ADDENDUM NO. 1

Date: August 11, 2023
Project Name: Runway 18L-36R Pavement Reconstruction
Owner: Denton Enterprise Airport
TxDOT CSJ No.: 2318DENTN
Garver Project No. 23A11280

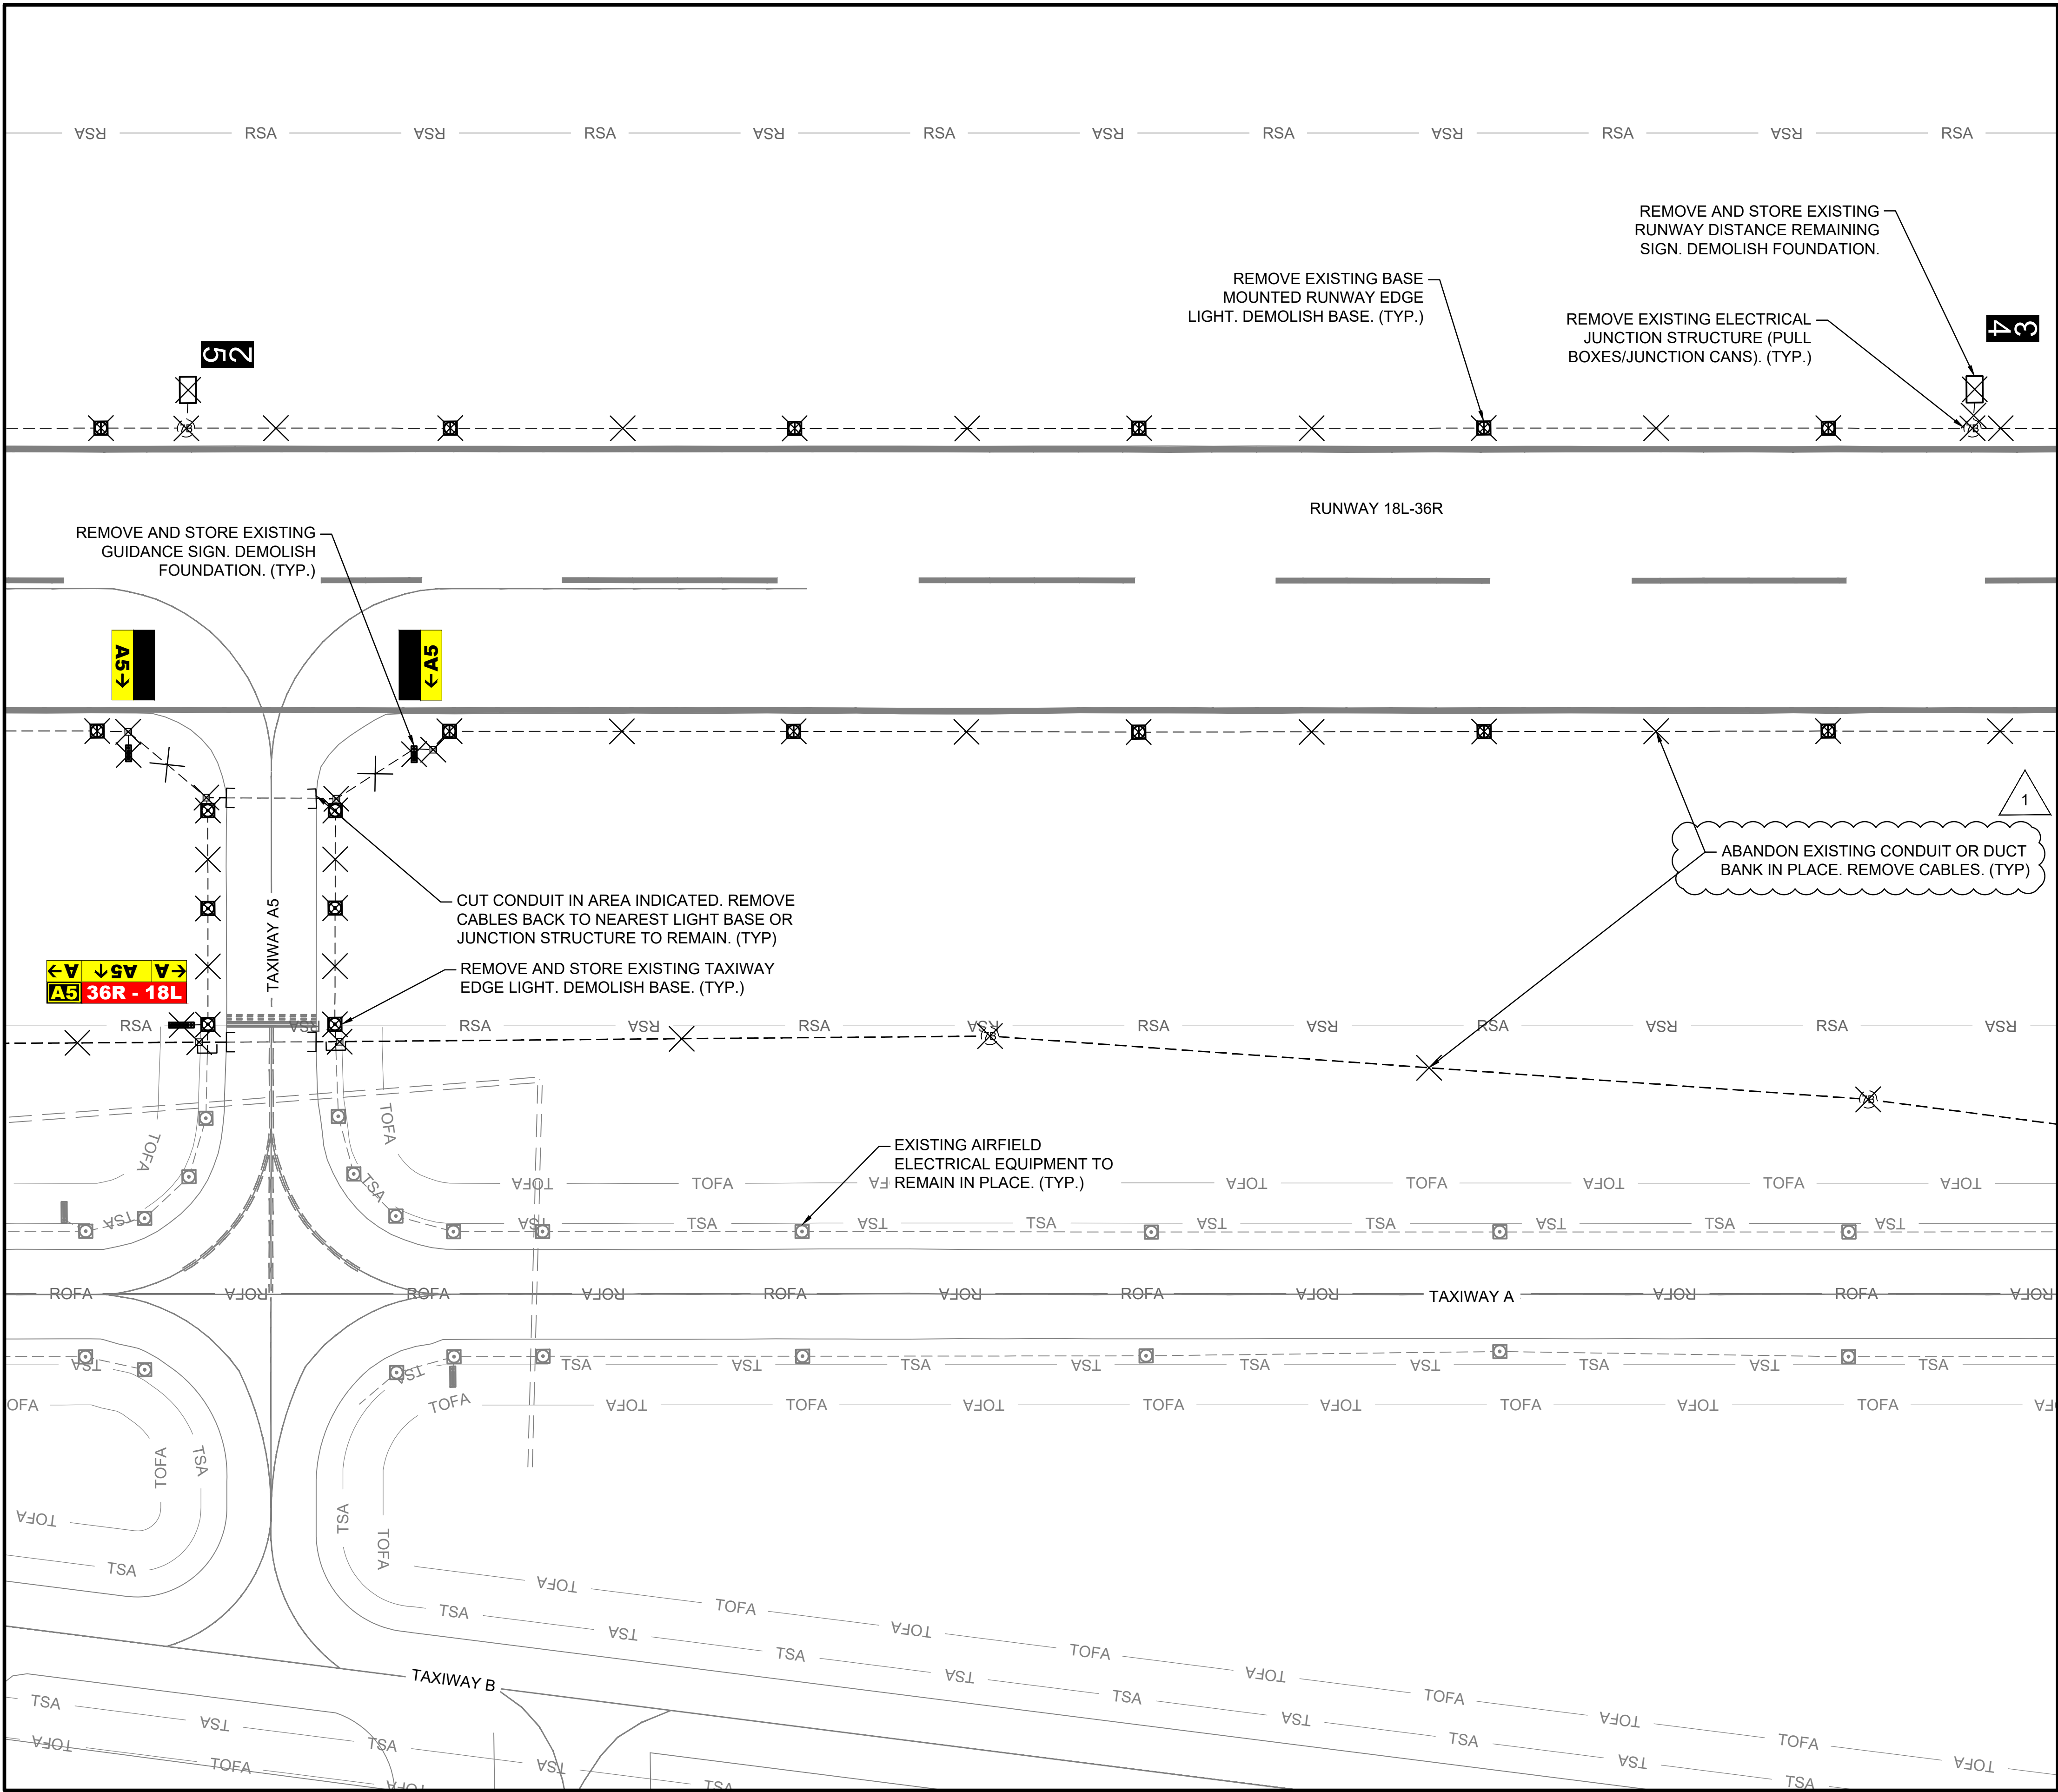
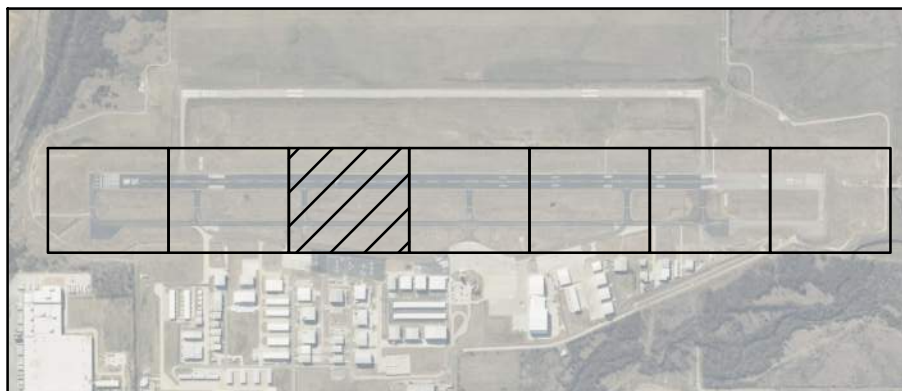
7. Updated Lighting Removal Plan, updating conduit removal detail, and the PAPI removal. Sheet "ED-102 Lighting Removal Plan 2"
8. Updated Lighting Removal Plan, updating conduit removal detail, and the PAPI removal. Sheet "ED-103 Lighting Removal Plan 3"

DRAWING NUMBER
ED-105

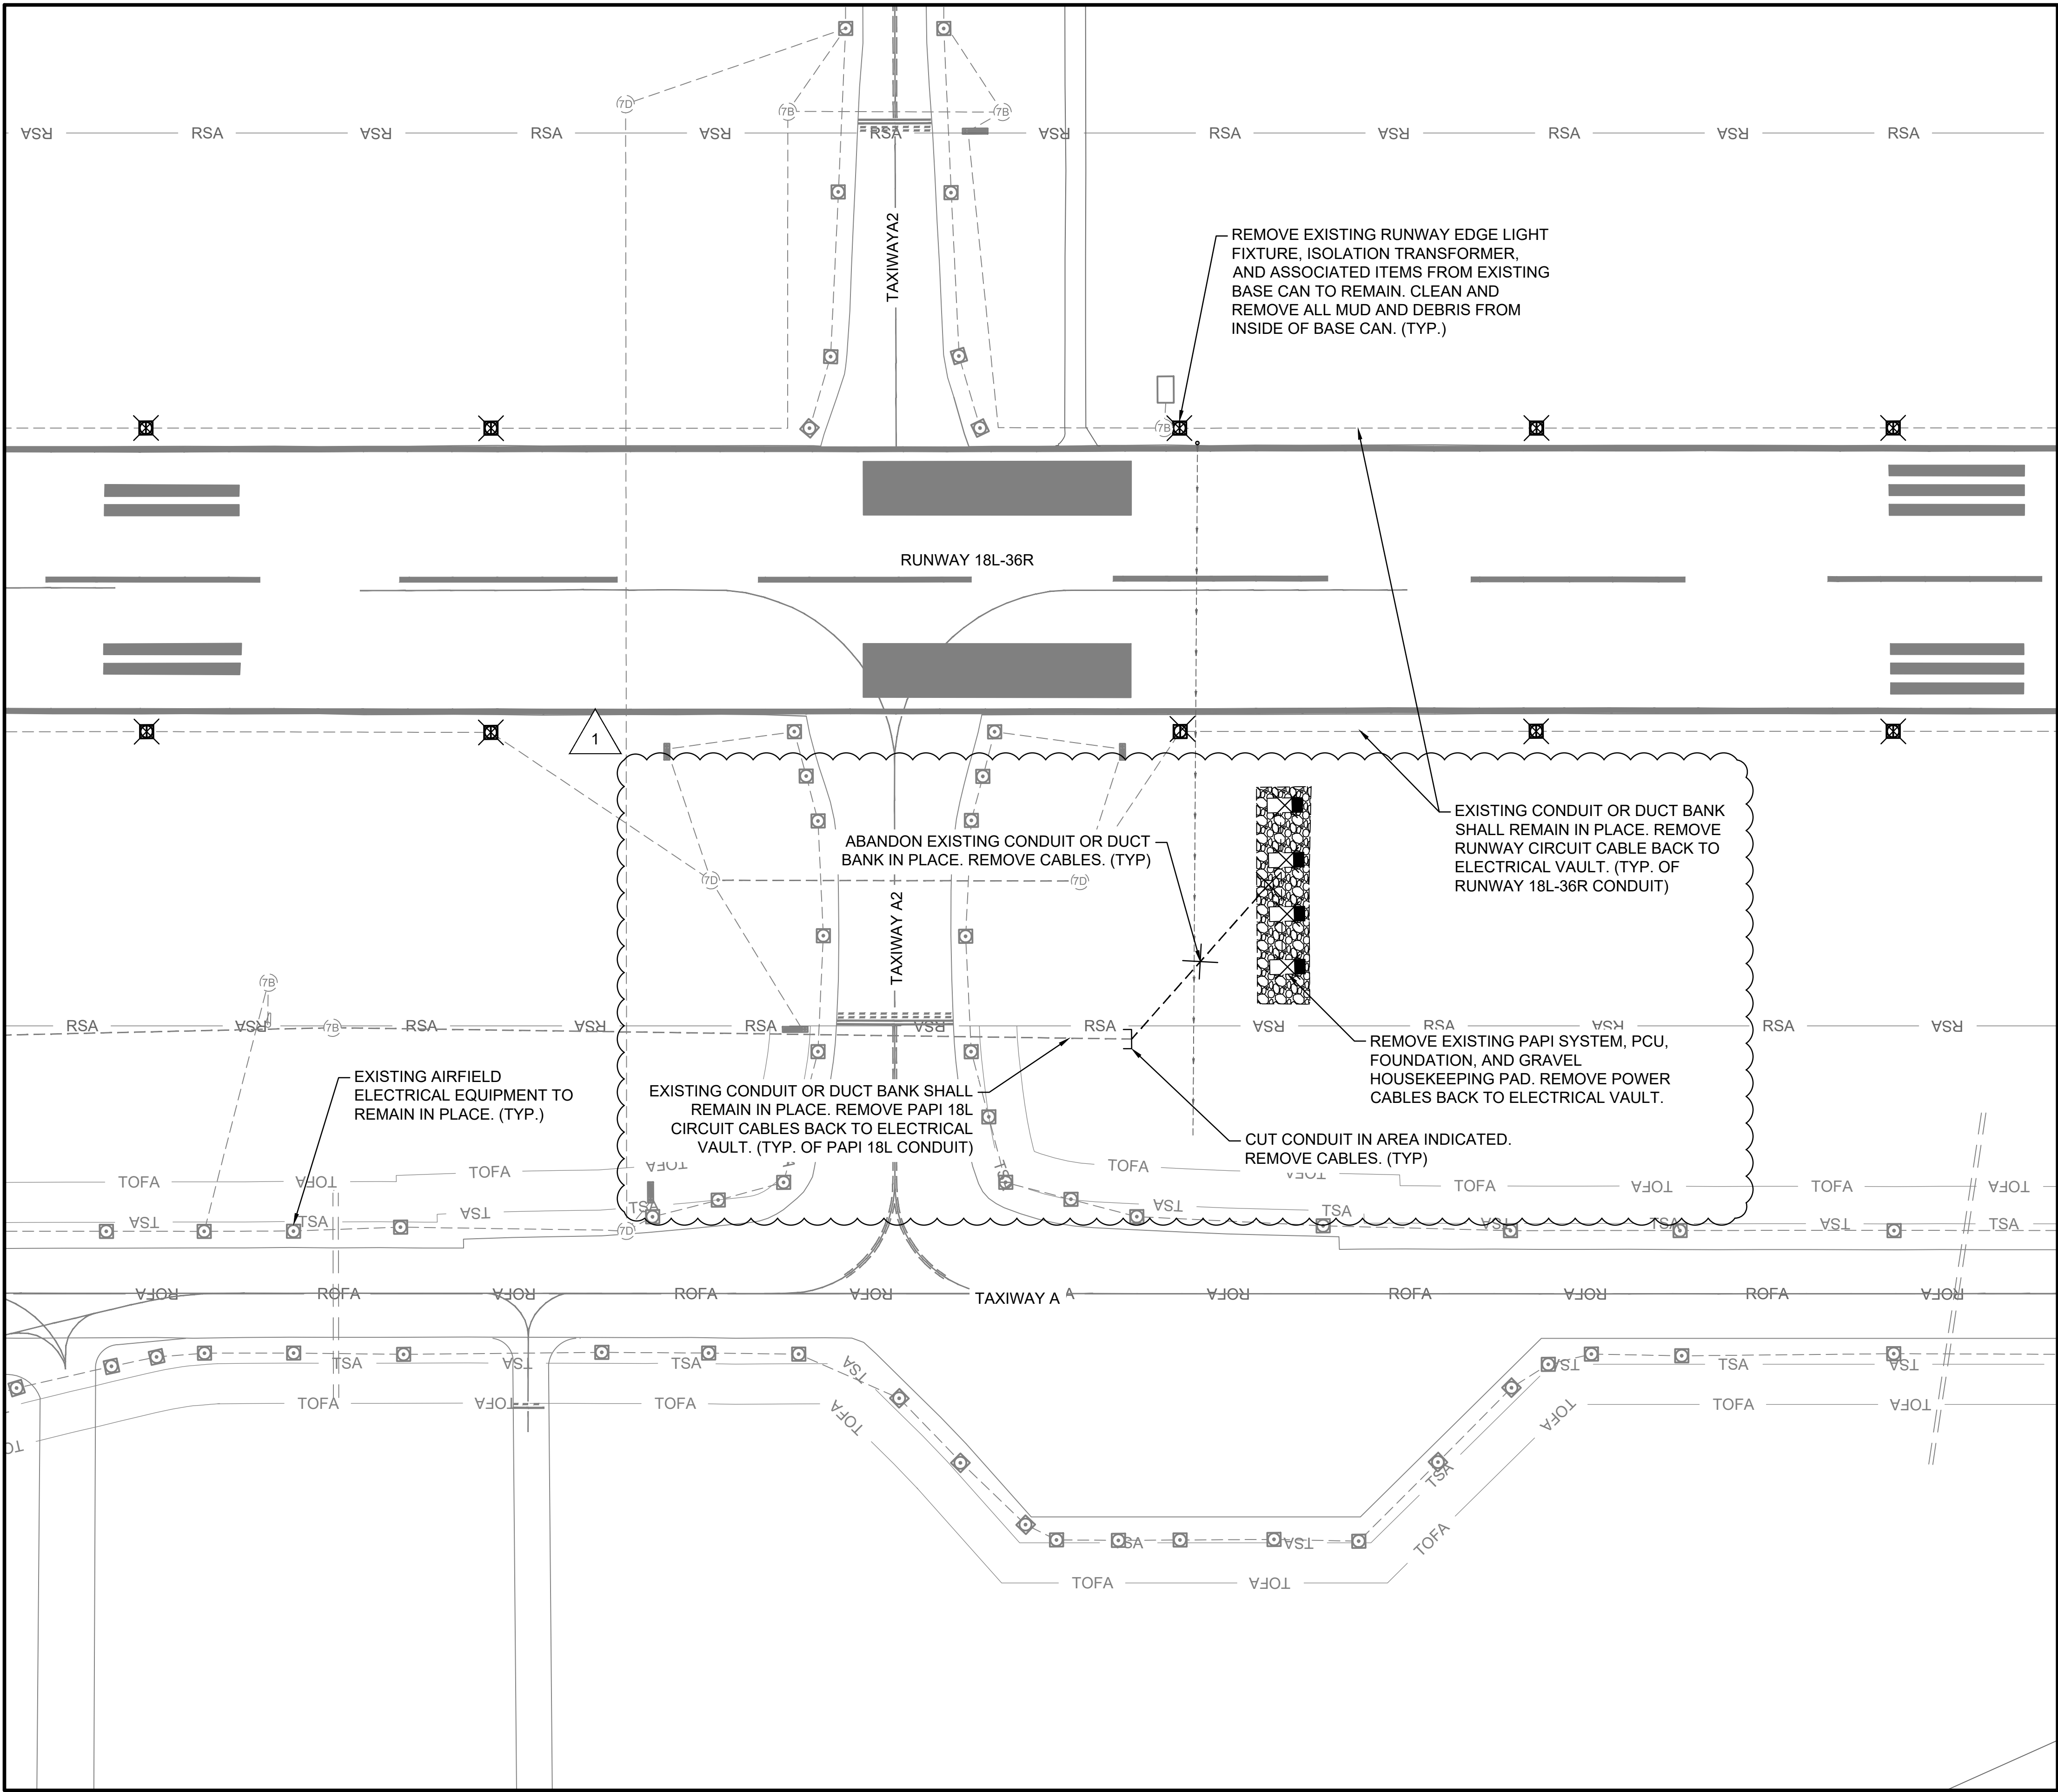
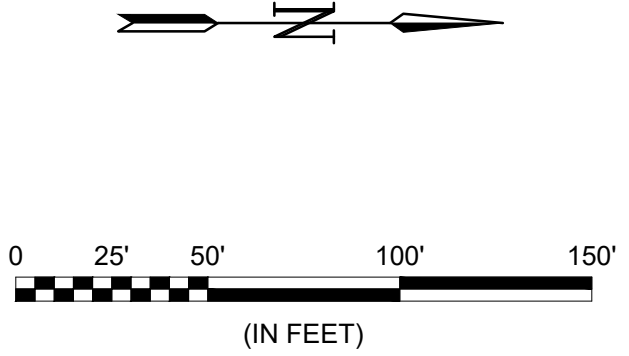
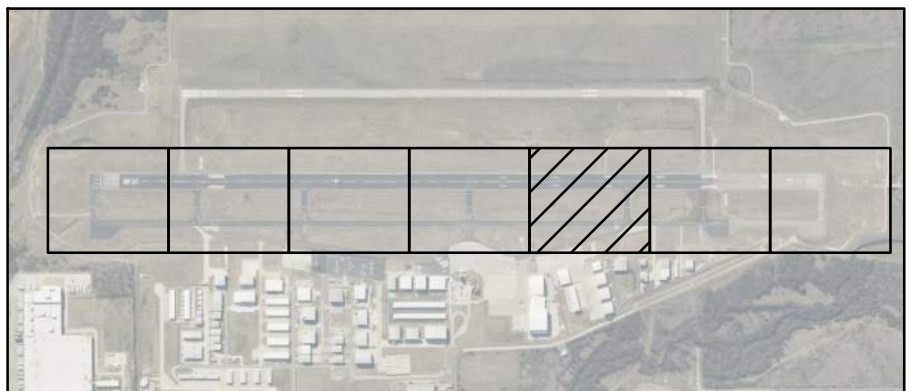
9. Updated Lighting Removal Plan, updating conduit removal detail, and the PAPI removal. Sheet "ED-104 Lighting Removal Plan 4"
10. Updated Lighting Removal Plan, updating conduit removal detail, and the PAPI removal. Sheet "ED-105 Lighting Removal Plan 5"
